Three Mile Island Nuclear Station
Special Operating Procedure

1. Title INSTALLATION of Temporary Isolation Transformers for Selected Pressurizer Heaters

TMI UNIT NO. 2
 BURNS AND ROE, INC.
 ENGINEERING CHANGE MEMO
 (REV 12/75)

SERIAL NO. ECM 3475-003
~~S-9202~~
 DISCIPLINE ELECTRICAL
 SUBJECT PRESSURIZER HEATERS
 ATTACHMENTS 5

S9200 SHEET 1
 OF 5

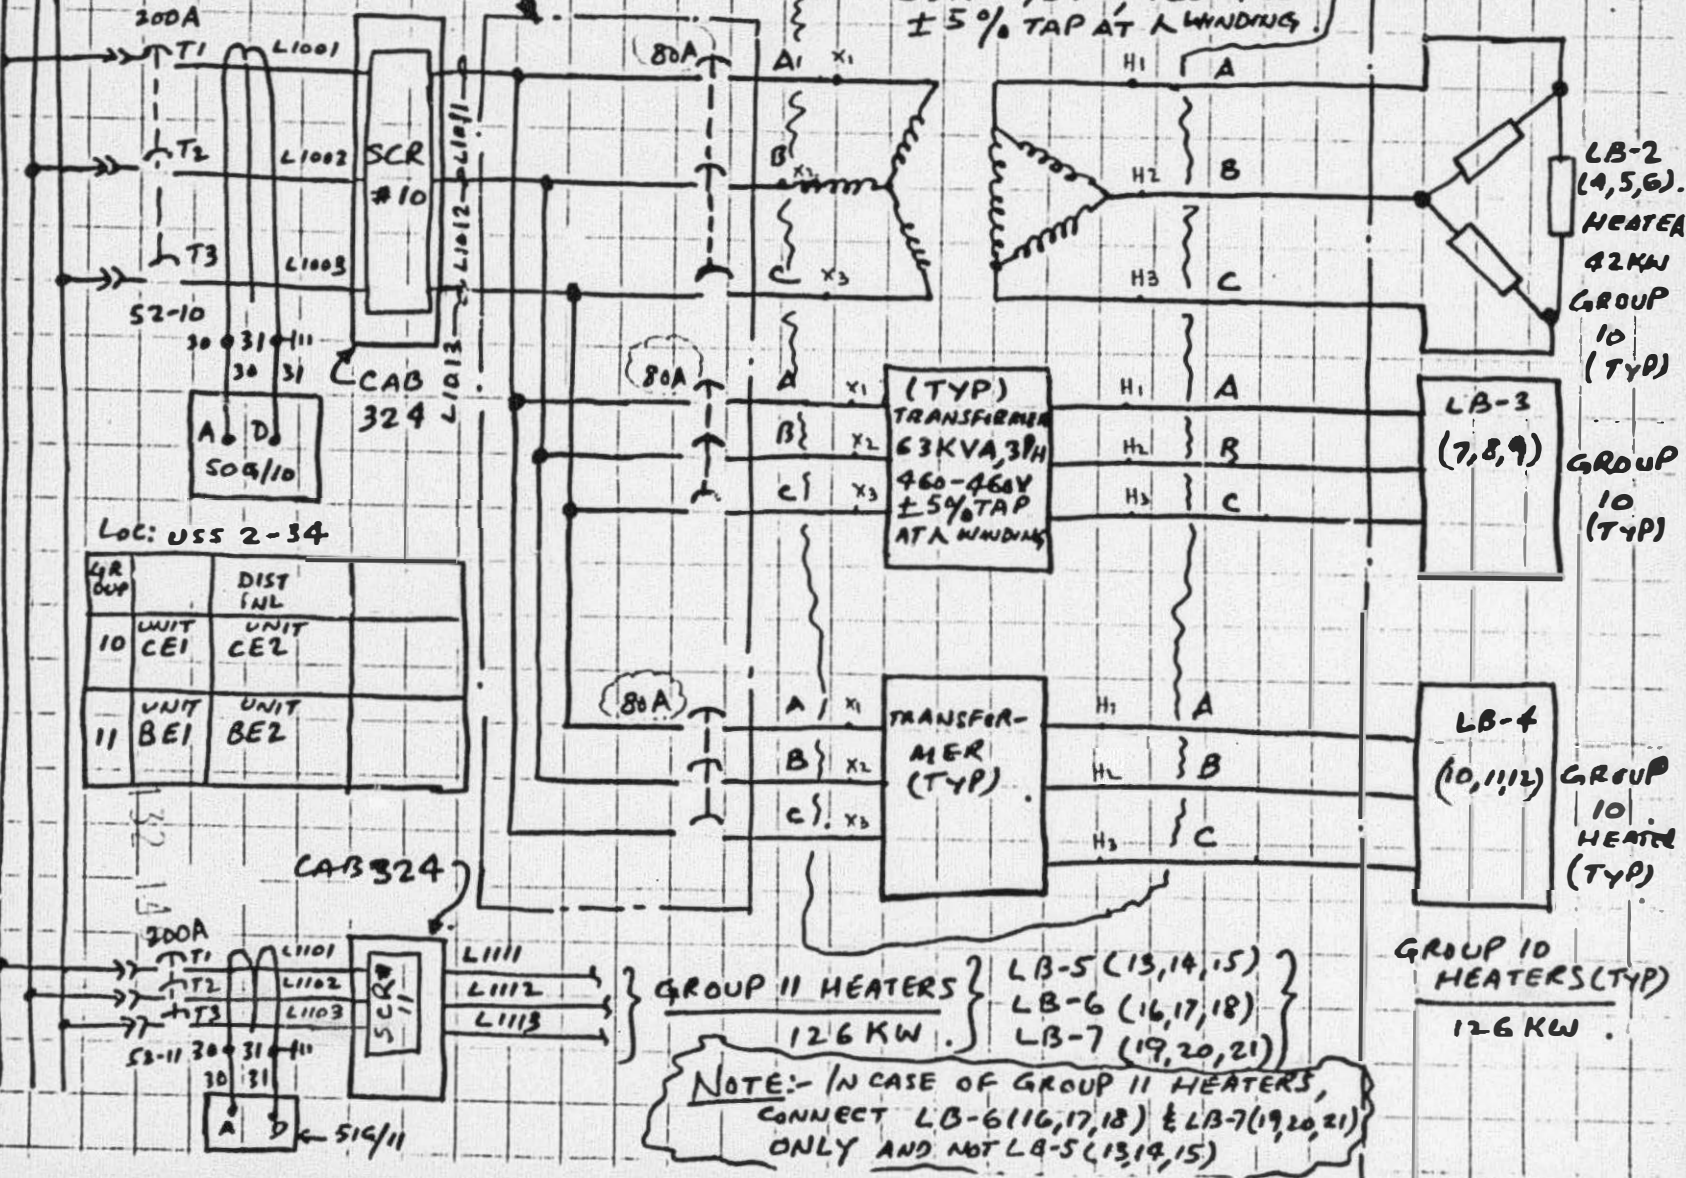
1. INSTALL ISOLATION TRANSFORMERS BETWEEN DISTRIBUTION PANELS AND PRESSURIZER HEATER AS SHOWN IN ENCLOSURES.
2. REPLACE 70AT EXISTING CIRCUIT BREAKERS BY 80AT CIRCUIT BREAKERS.
3. ADD NEW CABLES AS IDENTIFIED ON THE ENCLOSED SKETCHES.

NOTE:- IN CASE OF GROUP II HEATERS,
 CONNECT LB-6 (16,17,18) & LB-7 (19,20,21)
 ONLY AND NOT LB-5 (13,14,15)

DIST. PNL HPIV

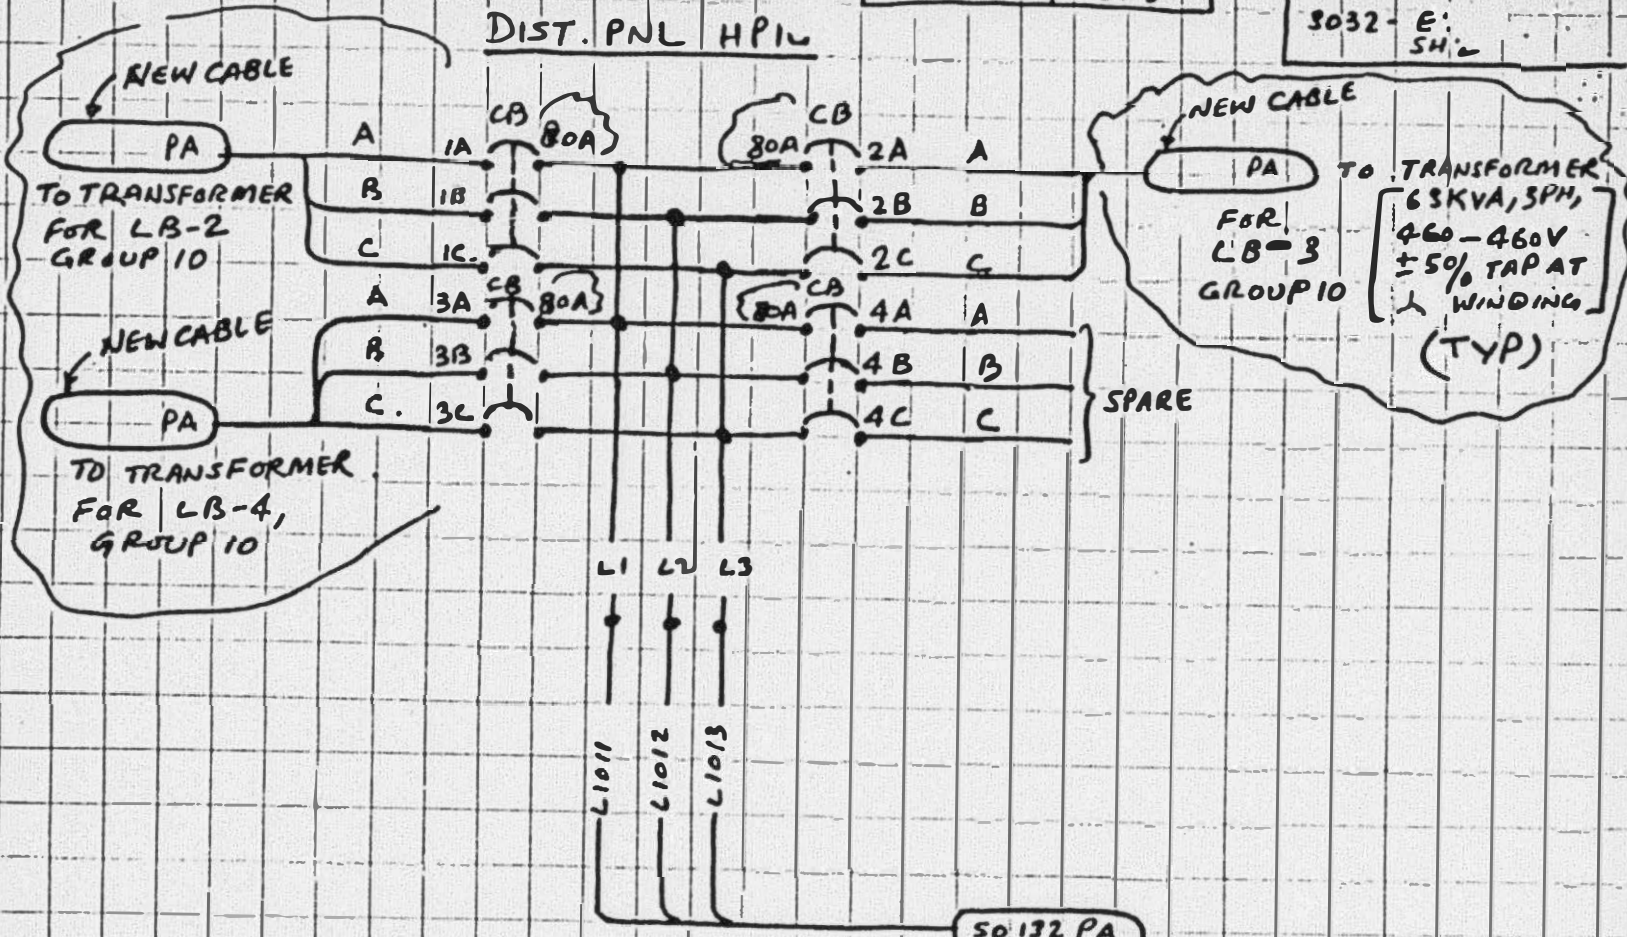
NOTE: THIS BREAKER MUST NOT BE CLOSED.

DWG
3082-E2
SH2.

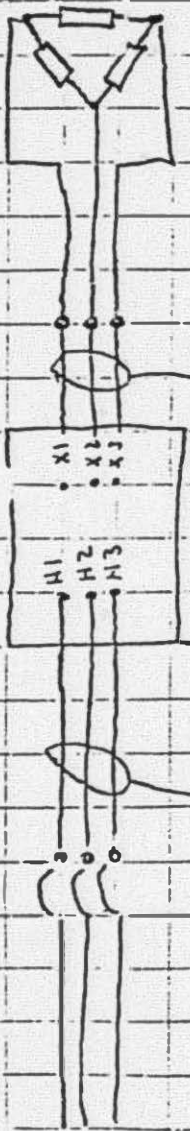
Temporary Cable

Connection - Use Same Size As Presently Installed

Internally Connect 3 to 4
